**ADDENDUM #1**

**RFB #24-0011**

**ADDITIONS AND ALTERATIONS – HOUSEHOLD HAZARDOUS WASTE**

**Addendum Number One**  
To The Drawings and Specifications for  
**Household Hazardous Waste Facility**  
**Bid # 24-0011, Sedgwick County, Kansas**

SHEET  
**AS1.3**  
OF SHEETS

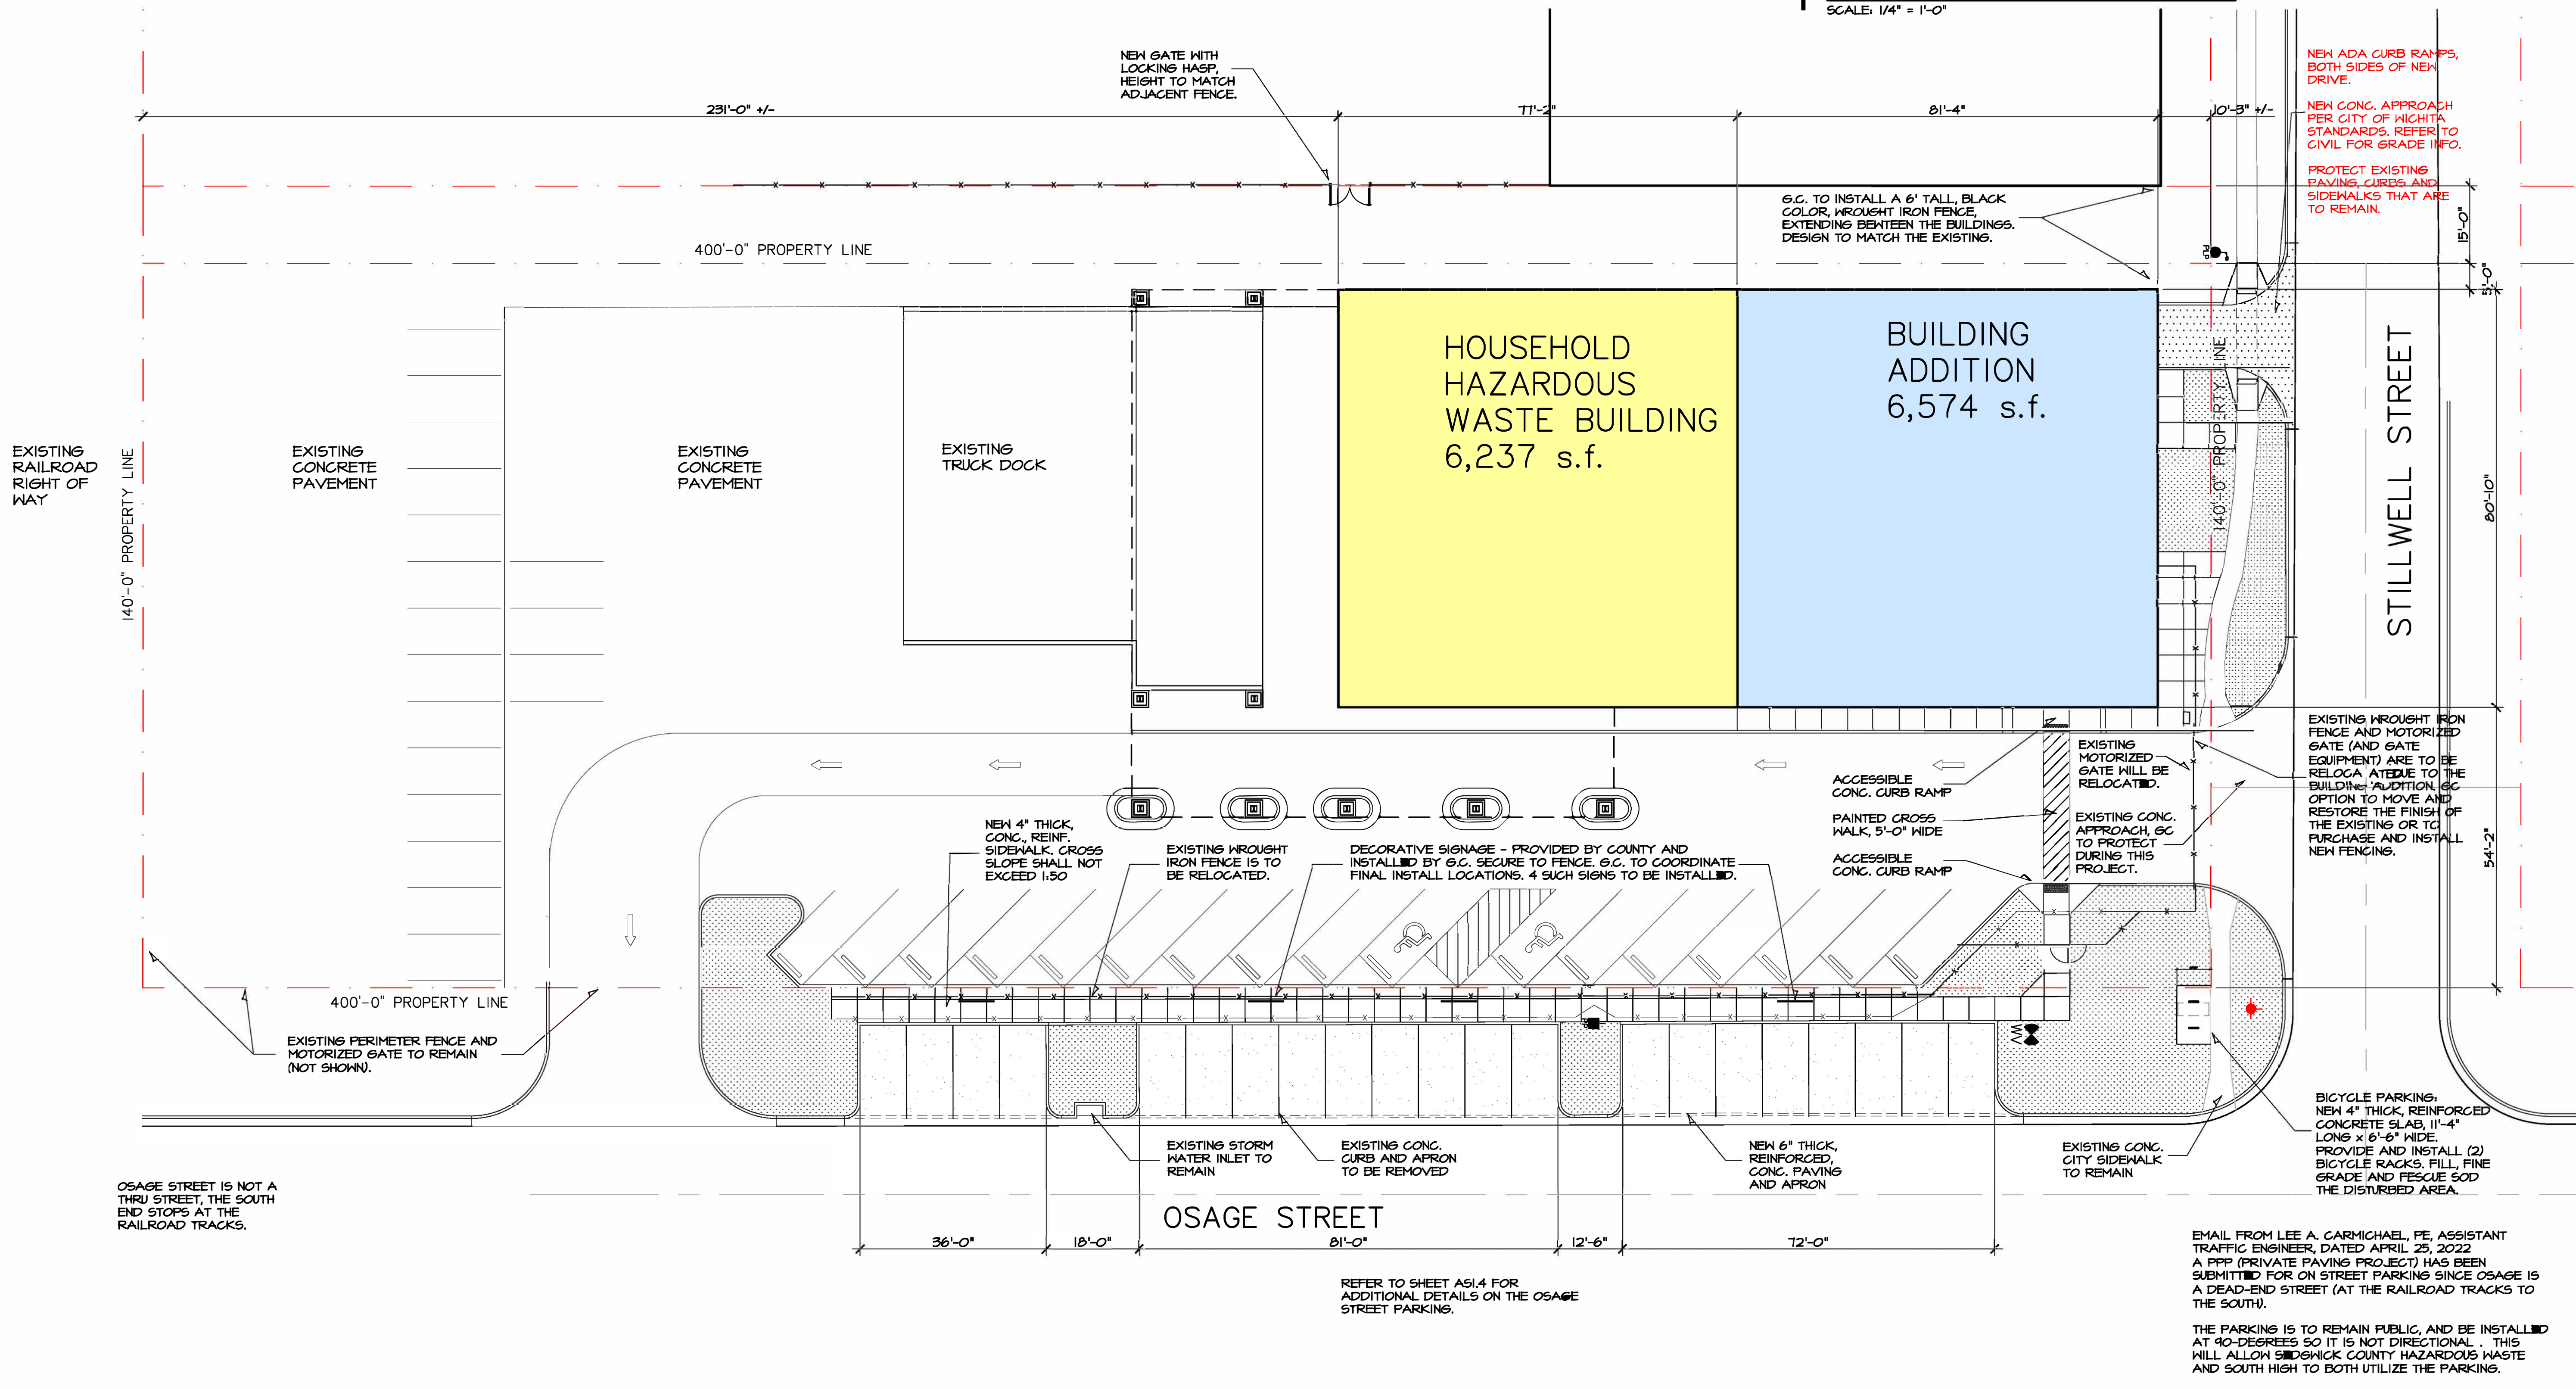
- 3.6 Sheet AS1.3
- a. This sheet is being reissued with this addendum.
  - b. The drive extending to the north from the new garage is new construction. This shall include a new curb, cut per the City of Wichita standards, curb and sidewalk modifications.

- c. Add new concrete splash block to each down spout located on west side of new addition. Refer to detail 11/ AS1.5. Please note, these are not shown on the new Sheet AS1.3, but are required.

- c. There is an existing power pole that will be in the new sidewalk (at the island with the stormwater inlet). Provide an additional 5 feet of sidewalk, 5-feet in width to the east side of the new walk. This additional concrete will allow pedestrians to walk around the power pole. Refer to the reissued Sheet AS1.3.

SHEET  
A5.4  
 OF SHEETS

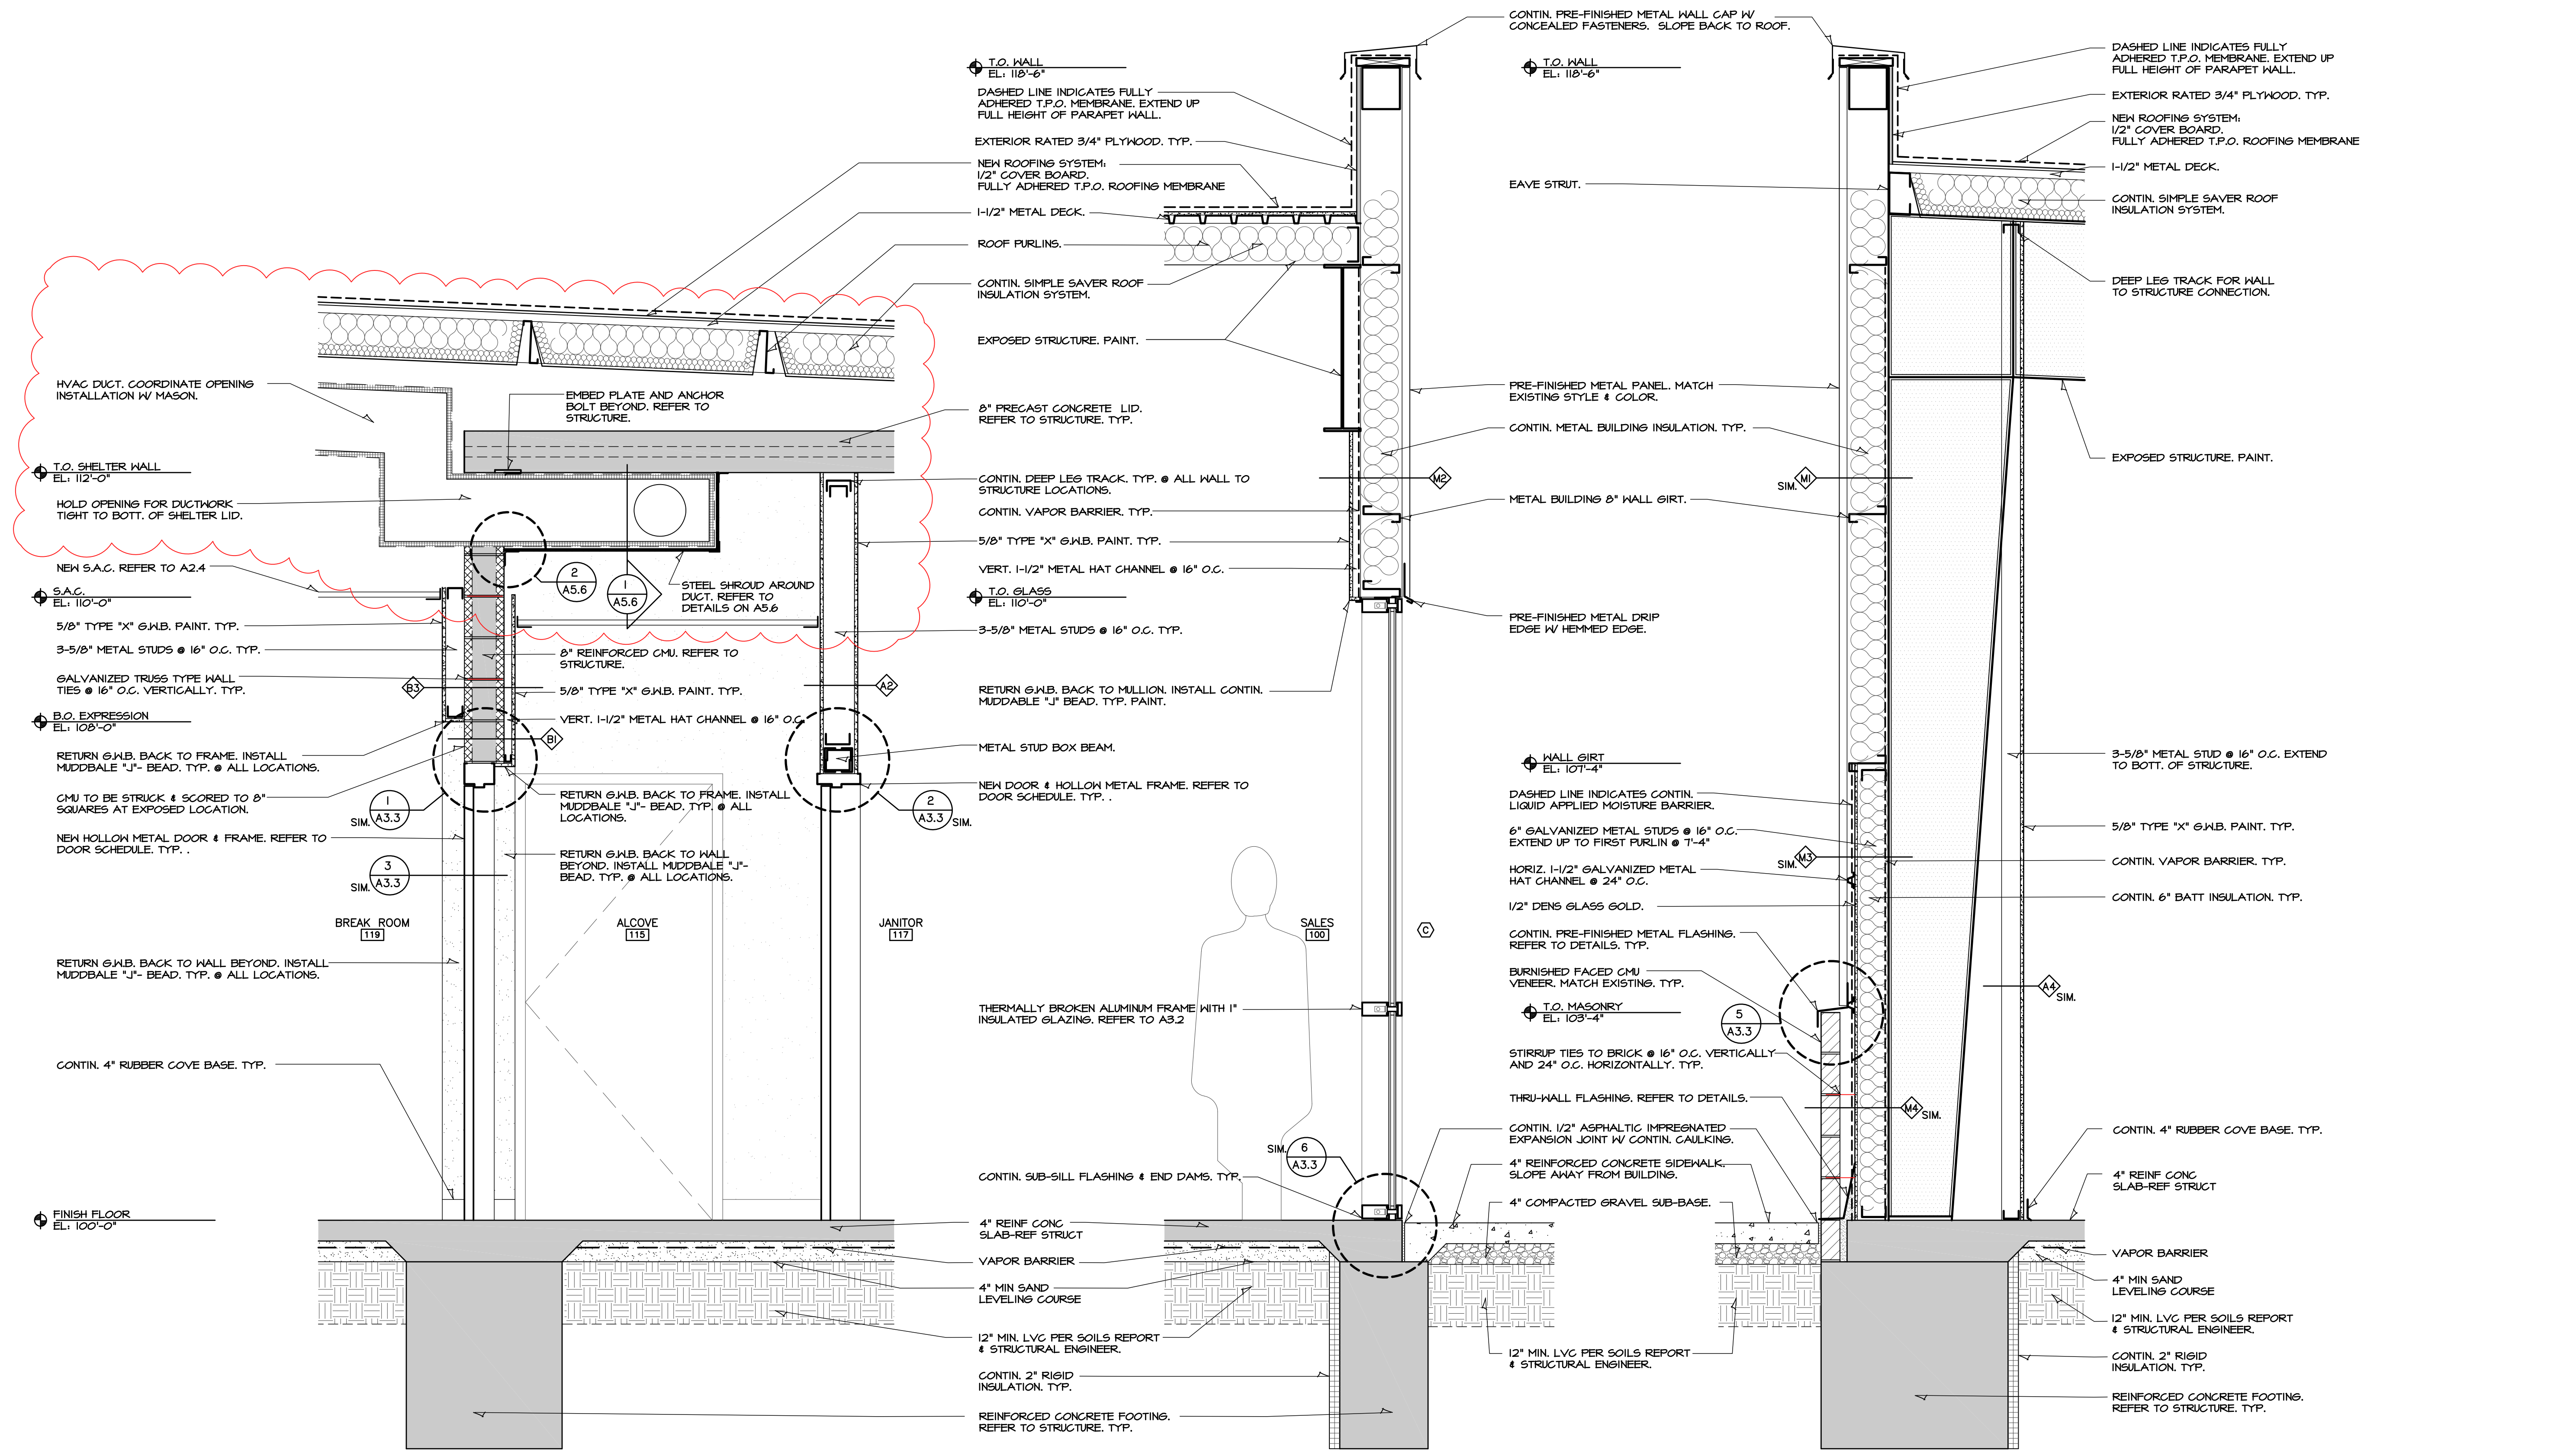
- 3.14 Sheet A5.4
- This sheet has been revised to clarify details of the HVAC duct coming into the hardened storm shelter.
- 3.15 Sheet A5.6
- This sheet has been revised to show details of steel ductwork wrap for the shelter.
